Subject: **BLACK HORIZONTAL STRIPES AT POWER ON**

Model: **PVM-1351Q/1354Q/1353MD**

Serial No: **2,009,901–2,010,250 (PVM-1351Q)**
2,006,601–2,007,000 (PVM-1353MD)
2,001,651–2,016,850 (PVM-1354Q)

Figure 1

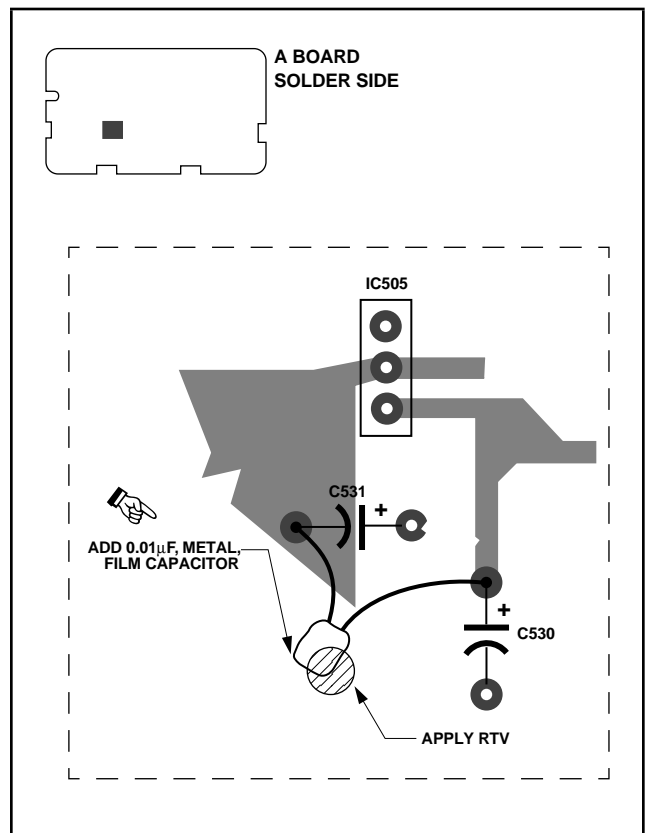
At low temperature, four or five black, horizontal stripes may appear in the center of the screen, at power on, then disappear when the unit warms up. This occurs due to a disturbance in vertical deflection.

To correct such an occurrence, solder the metal capacitor listed in the parts required table below to capacitors C530 and C531 on the A board (solder side, zone F-4), as shown in Figure 1. Apply RTV to secure the metal capacitor to the board.
